NEW ELEMENTARY SCHOOL
9801 HIGHLAND KNOLLS DR
BAKERSFIELD
CALIFORNIA
93306

NEW MIDDLE SCHOOL
4115 VINELAND ROAD
BAKERSFIELD
CALIFORNIA
93306

SHEET TITLE
**LIGHTING PLAN
BUILDING B**

E-132B
SHEET OF

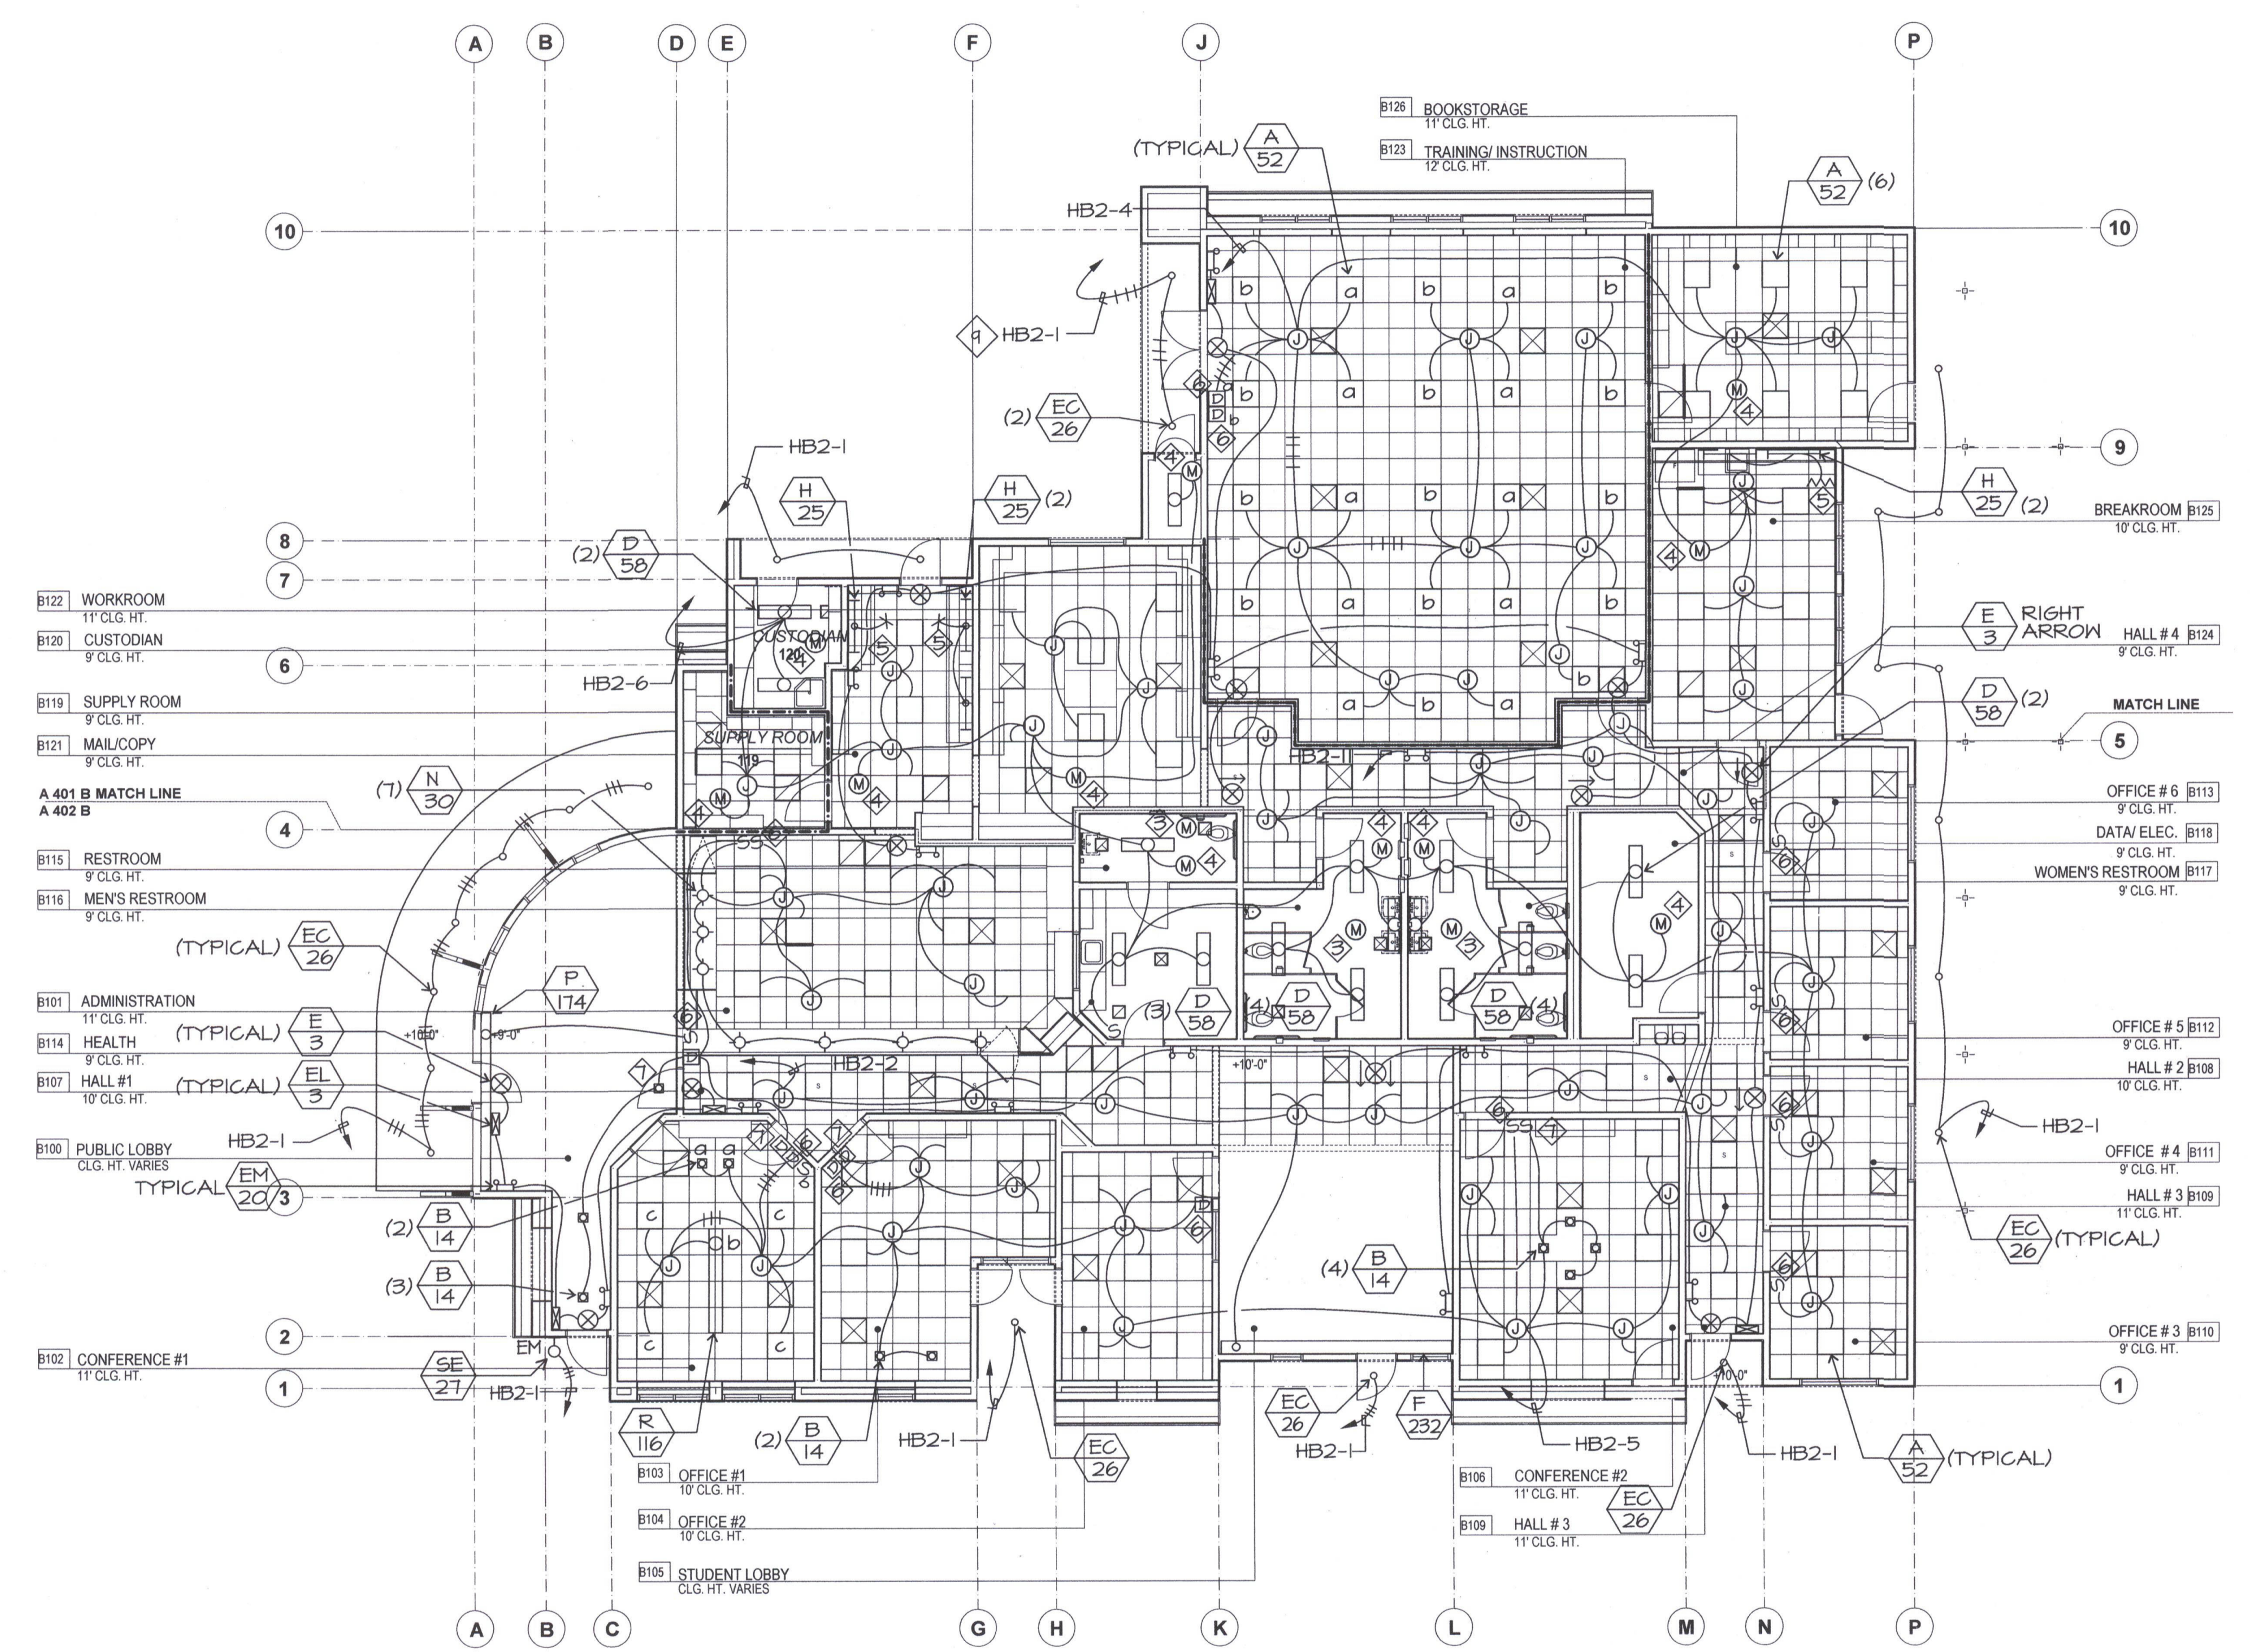
A/C Electric - 2/14/12
Sheet E-132B, Rooms B106, B102 & B103 show 5-0-5-7-7 as the lighting control. If the 5-0-5-7-7 is a Lutron DSVC277 dimmer and the 5-0-7-7 is a Lutron T0130 Dimmer, they need to be in separate switch boxes as the Lutron DSVC277 dimmer and the Lutron T0130 Dimmer are not compatible. In this case, please specify both dimmers. Both should be under one cover in the same box. Lutron DSVC277 dimmer, Lutron T0130 Dimmer, 2 gang pass - Lutron.

REQUEST:
RFI Electric - 10/18/12
Reference Sheet E-132B, E-132B & E-132C.
1. The Light Fixture Schedule calls out for a Type F light fixture to be installed in Room B105. The Electrical Plans for Building B show a Type F light fixture to be installed in Room B105, but this fixture measures out to be 16 feet long. Is this (1) Type F light fixture to be 16 feet long as called out for on the Fixture Schedule or does it need to be 18 feet long? Please advise.

2. The Light Fixture Schedule calls out for a Type P light fixture to be 12 feet long. The Electrical Plans for Building B show a Type P light fixture to be installed in Room B100, but this fixture measures out to be 14 feet long. Also, the Electrical Plans show a Type P light fixture to be installed in Room B101, but this fixture measures out to be approximately 19 feet long. Please confirm the lengths and quantities of the Type P light fixtures in Rooms B100 and B101.

REQUEST:
RFI Electric - 12/10/12
Reference Sheets A131B & E132B
1. Per the Electrical Plan for Building B, there is (1) Type B light fixture that is to be installed just outside door B108. However, this light fixture is not shown on the Architectural Plan for Building B. Which layout is correct? Please advise.
2. Per the Architectural Plan for Building B, there are (5) ceiling mount light fixtures shown to be installed along the radius, just off Gridline B, in Room B100. However, these (5) light fixtures are not shown on the Electrical Plan for Building B. Are these light fixtures required? If so, what type of light fixtures are they? Please advise.

REQUEST:
RFI Electric - 12/11/12
Reference Sheet A131B & E132B
1. Per the Electrical Plan for Building B, there is (1) Type B' light fixture that is to be installed just outside door B108. However, this light fixture is not shown on the Architectural Plan for Building B. Which layout is correct? Please advise.
2. Per the Architectural Plan for Building B, there are (5) ceiling mount light fixtures shown to be installed along the radius, just off Gridline B, in Room B100. However, these (5) light fixtures are not shown on the Electrical Plan for Building B. Are these light fixtures required? If so, what type of light fixtures are they? Please advise.

ANSWER:
John Maloney - JMPE - 11/2/12
1. Room B105 - Type F is 16ft long
2. Room B100 - Type P is 12ft long
3. Room B101 - Type P is 12ft long

ANSWER:
Joe Covington - CMA - 12/11/12
1. Type B' fixture to be relocated per Item #2.
2. At Room B100 - Other (5), only one Type B' fixture to be relocated to Room 100. Add one Type A' fixture per attachment. At Room B100 - Public Lobby, omit 2 Type B' fixtures shown on A131B (2 shown), relocate 1 Type B' fixture from adjacent door B108 to soft, adjust location of attic access panel as required. See attachment.

ANSWER:
Joe Covington - CMA - 12/11/12
1. Type B' fixture to be relocated per Item #2.
2. At Room B100 - Other (5), only one Type B' fixture to be relocated to Room 100. Add one Type A' fixture per attachment. At Room B100 - Public Lobby, omit 2 Type B' fixtures shown on A131B (2 shown), relocate 1 Type B' fixture from adjacent door B108 to soft, adjust location of attic access panel as required. See attachment.
